Wellington Village (FKA K Park)

STAFF REPORT

Petition Numbers: Rezoning
 2025-0003-REZ
 Ordinance No. 2026-06

Master Plan
 2025-0001-MP
 Resolution No. R2026-03

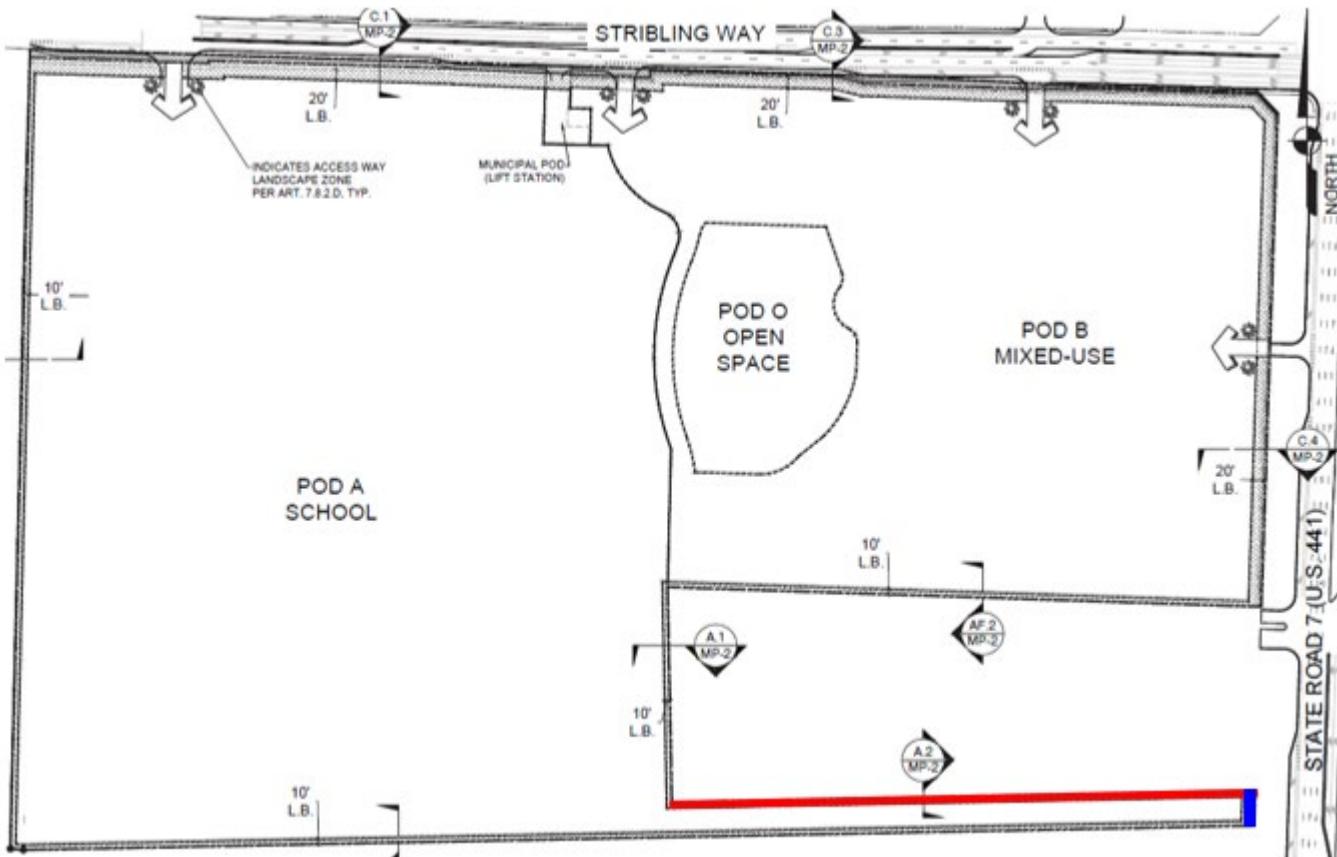
5. **Fence/Wall Location within Landscape Buffers:** Section 7.8.5.C.7 of Wellington's LDR states that if a fence or wall is required within a landscape buffer, the landscaping shall be located between the fence or wall and the adjacent property or right-of-way. The proposed PSM proposes that the fence or wall may be located at the property line where the adjacent property has an existing buffer for the west and south property lines for Pod A. There is no objection to this request.

6. **Outside Activity Area Buffers:** Section 6.2.2.F.5 of Wellington's LDR requires schools that have outside activity areas be buffered a minimum of 50 feet in width from adjacent residential. The athletic facilities proposed in Pod A are situated towards the southern portion of the site. A 10-foot wide Type A/F landscape buffer, which includes one (1) shade tree per 30 linear feet, a continuous hedge, and a fence or wall, is currently proposed along the entirety of the south property line with plantings both within this perimeter buffer and along the north side of the driveway. Additionally, a 25-foot-wide landscaped buffer exists beyond the southern property line of Pod A on the adjacent Farmington Estates neighborhood. There is no objection to this request as the intent of the outside activity area buffer requirement will be met through the existing landscape on the adjacent Farmington Estates property and the proposed site design.

Image D: Landscape Buffers

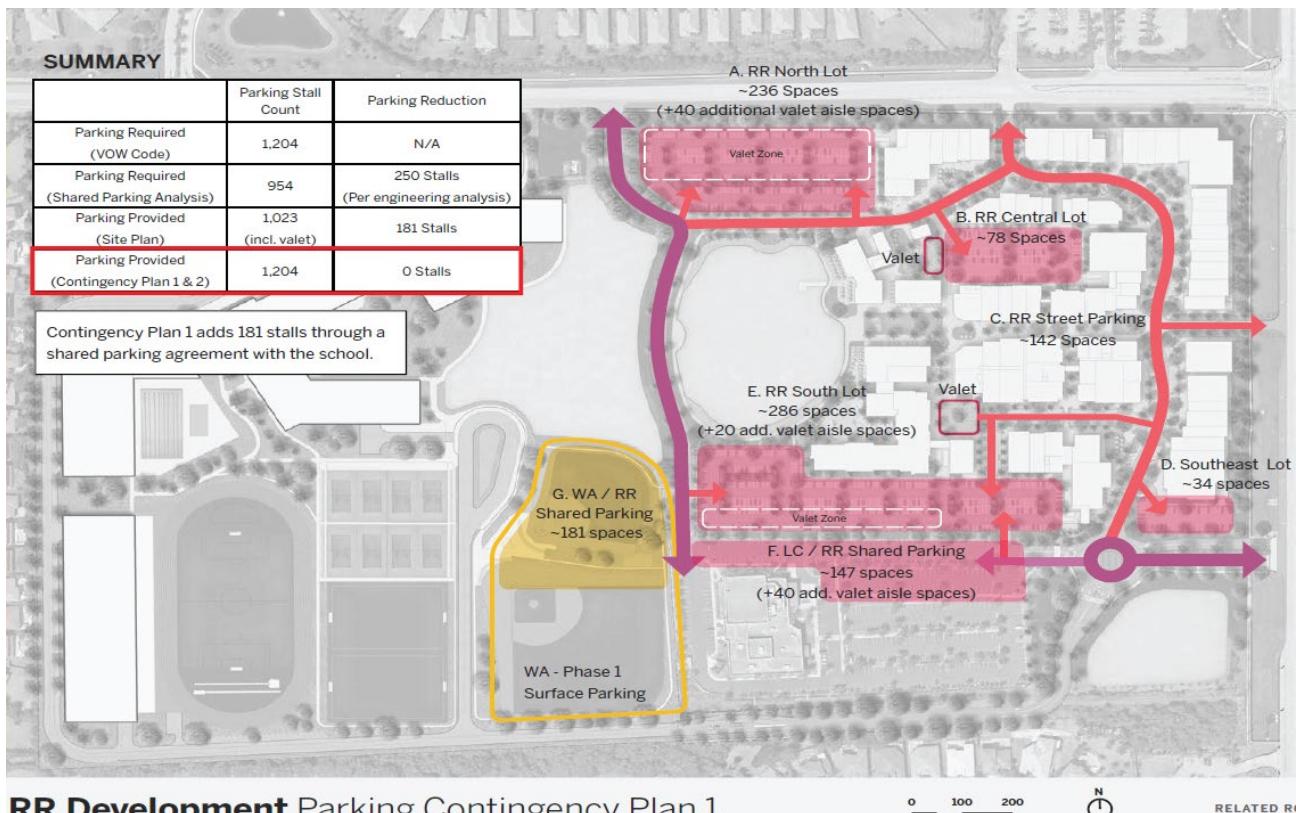
7. **Type A Buffer (North adjacent to Church parcel):** A modified 10-foot wide Type A buffer, which includes the elimination of the required shade trees for every 30 linear feet, is requested along the north side of the Pod A access easement south of the Church site (shown as the red line in Image D). The applicant is requesting the deviation due to the existing overhead utility lines along the access strip, which impact the ability to properly plant shade trees at the required height established in the LDR. FPL imposes "Right Tree, Right Place" requirements, which limit the type of species and height that are planted in areas that are beneath the overhead lines. As such, the proposed deviation

requested allows compliance with FPL requirements. A continuous hedge and Native ornamental grasses will still be planted. There is also existing buffer material on the church property that further screens the access drive within this area. There is no objection to this request.

Image E: High-Turnover Zone

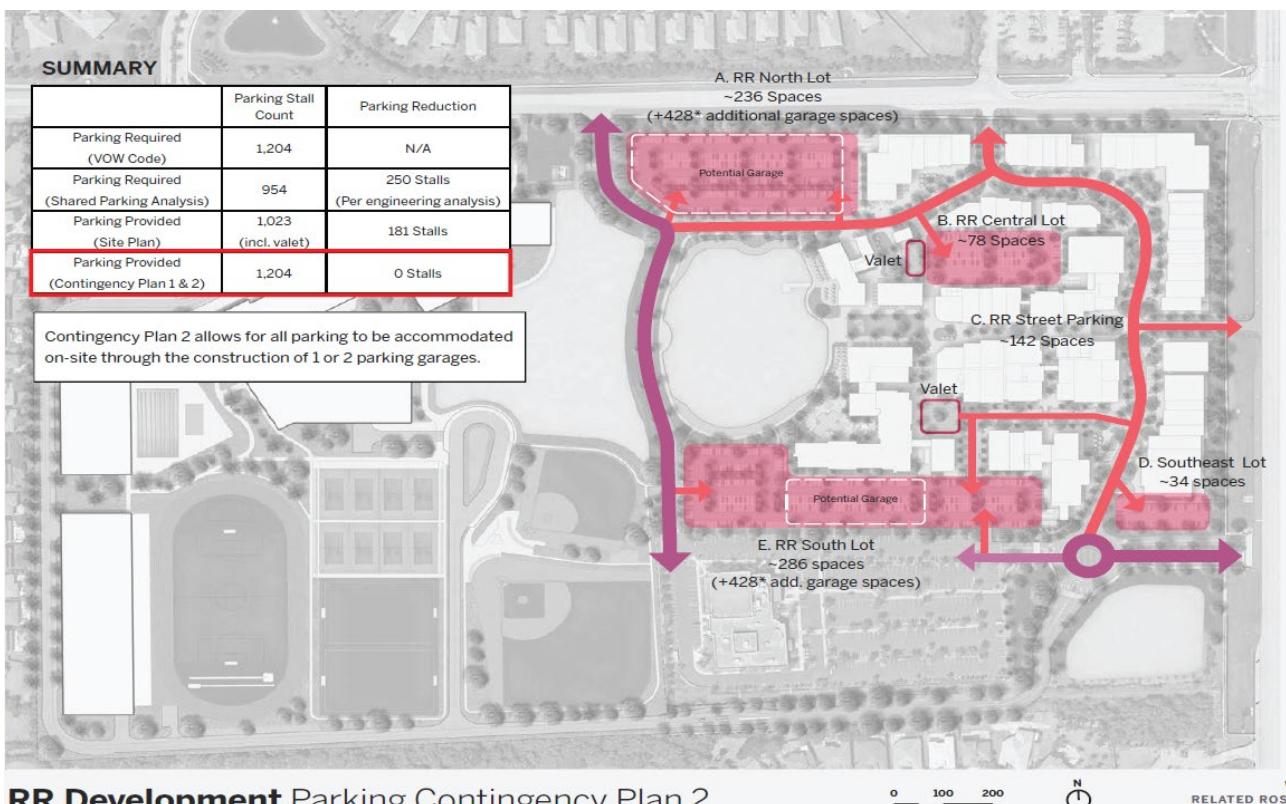
- Required Parking:** A deviation to the required parking for Pod B is requested. The LDR requires a total of 1,204 parking spaces, as both the retail and office parking rates are based on net square feet and not gross square feet. A parking study was prepared by Simmons & White and determined that the anticipated maximum parking demand for Pod B is 954 spaces (includes an additional 10% of spaces as a conservative buffer). Two (2) contingency parking plans were provided, shown in the images below, which include a shared parking agreement with Wingrove Academy (Pod A) within the adjacent future site for ball fields and the construction of a parking garage within Pod B. As a result, a monitoring condition is included in Resolution No. R2026-03, which requires the submission of an annual parking utilization monitoring study for a period of 10 years after the issuance of a certificate of occupancy for more than 150,000 square feet. If a parking deficiency is identified, the property owner will be required to construct the contingency parking within 18 months.

2. **Parking Stall Width:** Required parking stall width is 9.5 feet. The proposed Pod B PSM includes a parking stall width of 9 feet, which is not considered appropriate for high turnover areas. The areas considered in the "high Turn-Over Zone" shown in Image E are anticipated to be the most utilized and

desirable parking spaces for Pod B and are located along the Main Street corridor and the central parking lots closest to the storefronts. The parking lots west of Building A1 and south of the Hotel building are located in non "High-Turnover Zones" and are the subject of the deviation request to allow parking spaces 9 feet in width. There are no objections to this request.

Image H: Pod B Landscape Buffer

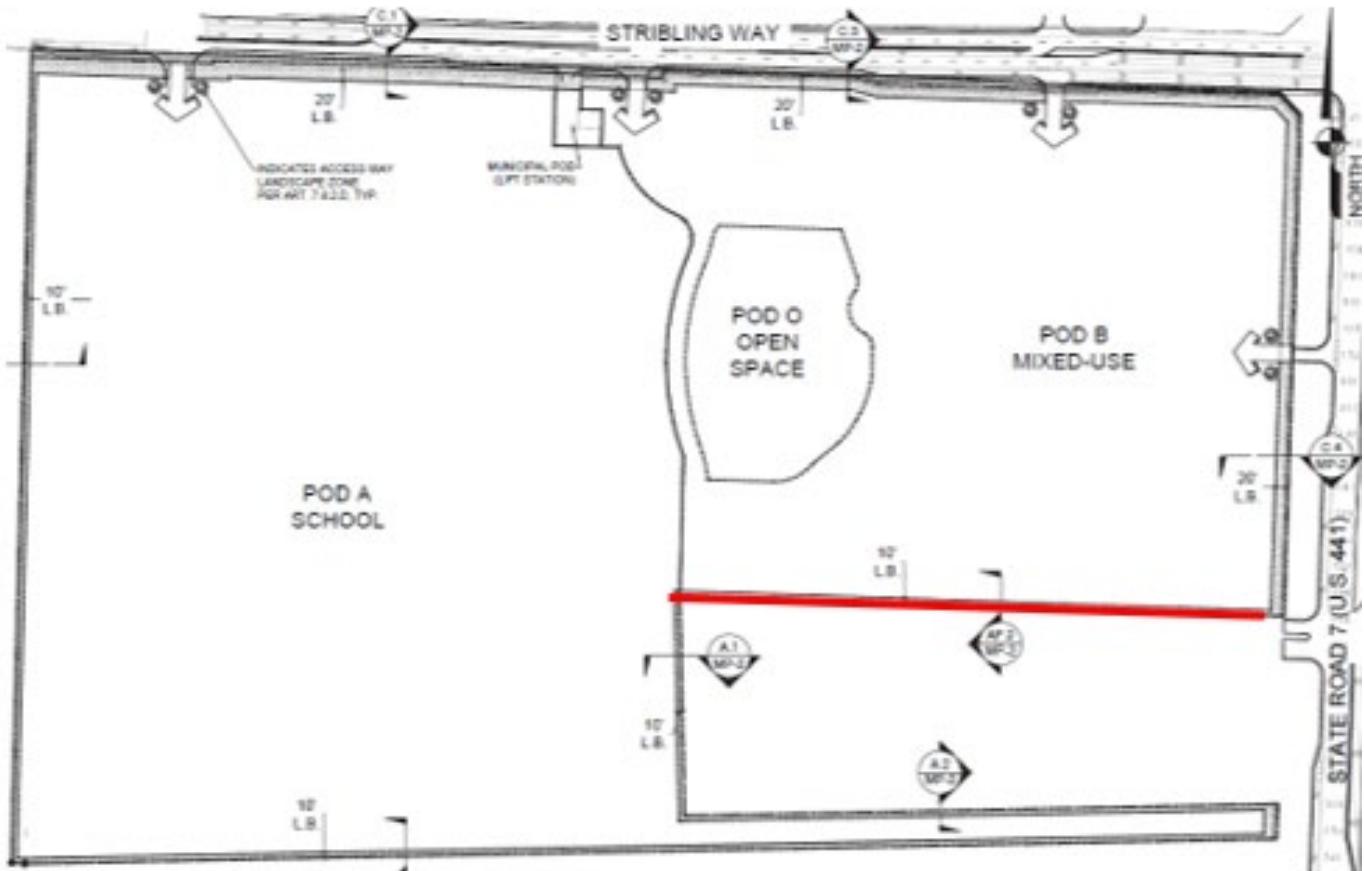
6. **Buffer Type A/F (South):** A landscape buffer deviation is requested to eliminate the required fence within Type A/F buffer for the southern property line adjacent to the Life Church property (shown as red line in Image H) at the request of Life Church. There is no objection to the request.
